Technical Service Bulletin (TSB)
Global Telematics Box Module (TBM) Firmware Over The Air (FOTA) Software Update from 4.34 to 4.36

REFERENCE:	TSB: 08-143-24 GROUP: 08 - Electrical	Date:	June 21, 2024	REVISION:	-
VEHICLES AFFECTED:	2020 - 2024 (B1) Jeep Renegade This bulletin applies to vehicles built on and after December 14, 2020 (MDH 1214XX) and on and before January 09, 2024 (MDH 0109XX) equipped with Global Telematics Box Module (Sales Code RDG).	MARKET APPLICABILITY:		<input type="checkbox"/> NA	<input type="checkbox"/> MEA
				<input checked="" type="checkbox"/> SA	<input type="checkbox"/> IAP
				<input type="checkbox"/> EE	<input type="checkbox"/> CH
CUSTOMER SYMPTOM:	Customers will not experience any symptoms.				
CAUSE:	TBM Update

Fig. 1
Software Acceptance Screen

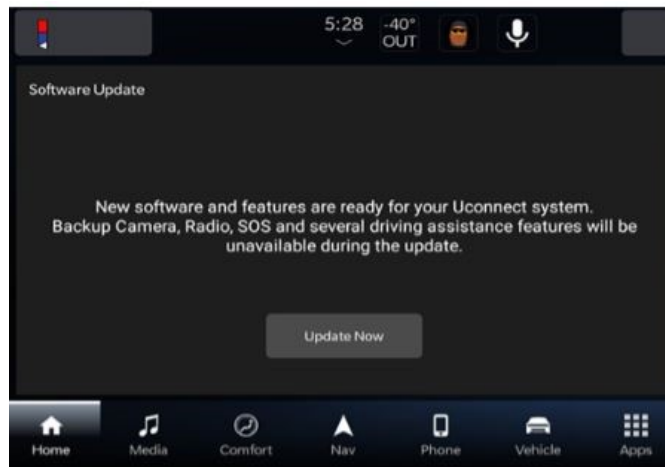
Vehicles sold in South America can now receive software updates “over-the-air”. Updates to software will occur in a phased roll-out. The software is updated through a built-in cellular modem in the vehicle. Customers will see a notification on their radio screen when new software is available for their radio Fig. 1. The owner will have the option to update the radio or schedule the update for later. There is not an option to decline the update indefinitely, the update must be performed.

1. The vehicle needs to be in 'Park'. The ignition needs to be in the off position.
2. If the customer selects "Update Now" they can shut off the vehicle and leave. The update will be completed automatically.

Fig. 2
Software Update Confirmation Screen

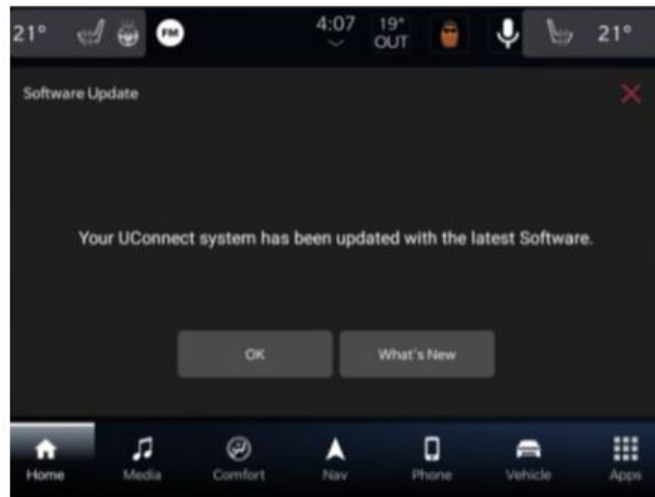
3. Upon completion of update, the radio will display a confirmation message [Fig. 2](#).
